KANSAS GAS AND ELECTRIC COMPANY

KMLNRC 84-048  
Re: Docket No. STN 50-482  
Ref: NRC Letter dated 2/29/84 from BJYoungblood,  
NRC, to GLKoester, KG&E  
Subj: Procedures Generation Package

RESPONSES TO  
REQUEST FOR ADDITIONAL INFORMATION  
WOLF CREEK GENERATING STATION  
PROCEDURES GENERATION PACKAGE (PGP)

Figure 1 - System Review/Task Analysis Procedure

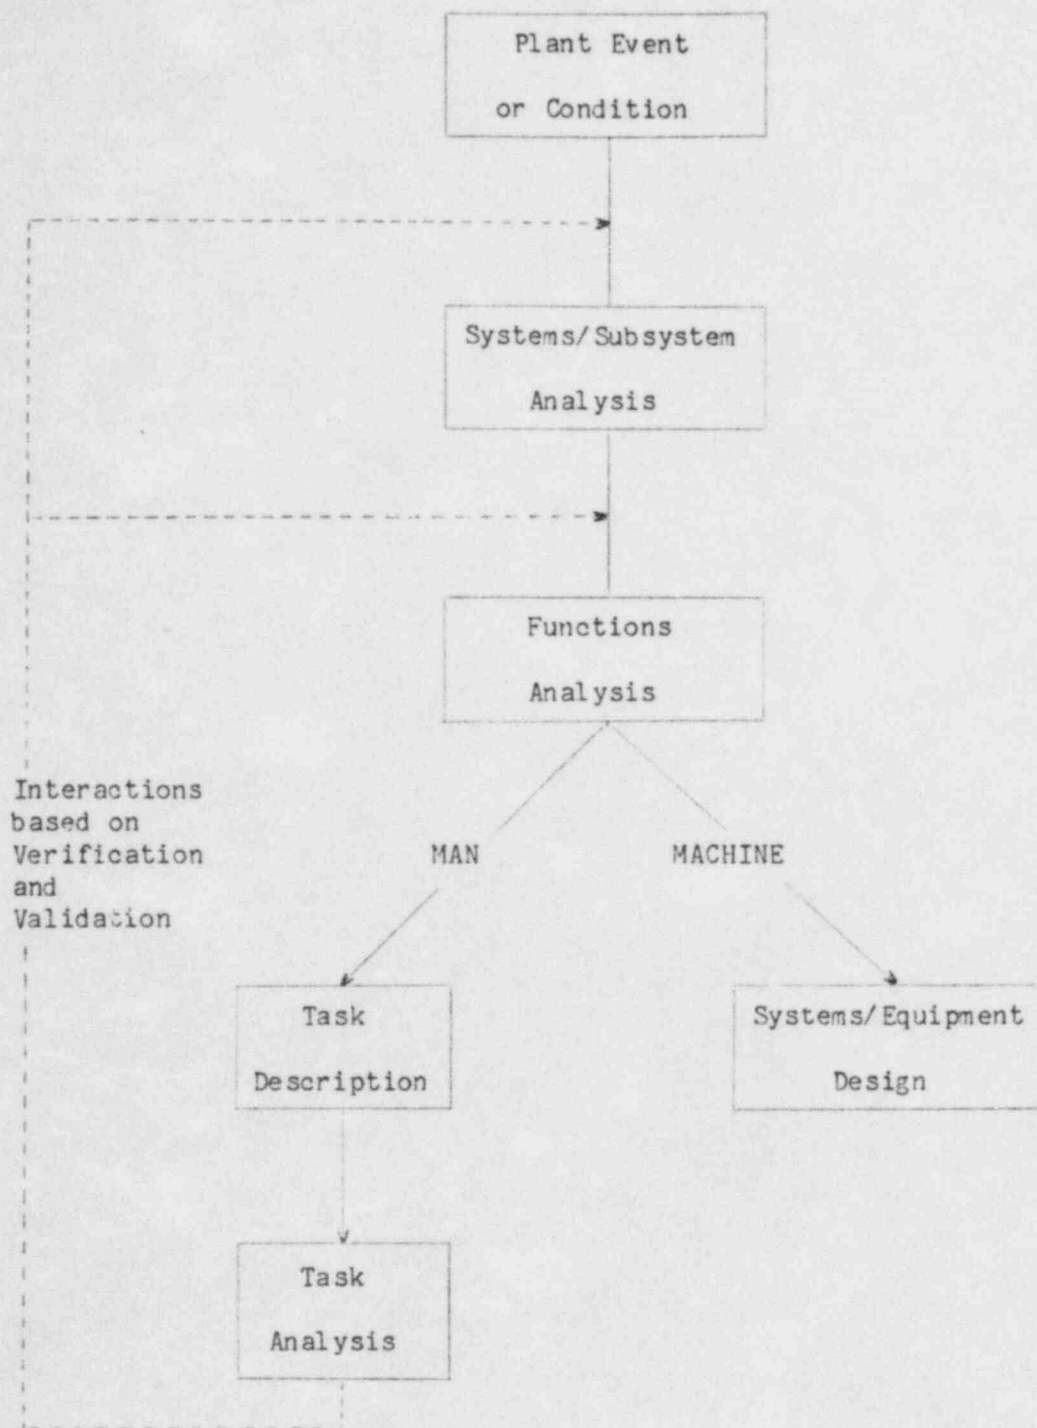
- a. identify operator information and control requirements, and
- b. use the information and control requirements in evaluating the adequacy of existing (or currently planned) instrumentation and controls. The staff is aware of the generic task analysis performed by the Westinghouse Owners' Group. The generic analysis appears, from the documentation we have reviewed, to be based on existing instrumentation for conducting a given task. In some cases, the tasks specified in the generic analysis are based on existing instrumentation. To complete our review of the plant-specific technical guideline portion of the PGP, we need to review your description of an analysis of information and control requirements for performing tasks based on the functional and system operational requirements.

R 4.b The general procedure for the system review and task analysis is illustrated in Figure 1. The starting point is an emergency plant event or condition. The term "plant event" is applied to transients or accidents that have been postulated by the plant designers and are recognized by the operators from the instrumentation available to them. The term "plant condition" applied to transients or accidents that may not have been postulated or are not recognized by the operators.

The systems/subsystems analysis referred to in Figure 1 has been performed on a generic basis for all Westinghouse plants by Westinghouse and the Westinghouse Owners' Group (WOG). Plant events postulated include all combinations of initiating sequences and single or multiple equipment failures with calculated probabilities of occurrence greater than  $10^{-8}$  per reactor year and many with probabilities lower than that. For these postulated plant events the systems and broad functional requirements to mitigate each event have been defined. This portion of the systems analysis is the basis for "event related" function analysis. Plant conditions (events not postulated or not recognized by the operators) have been
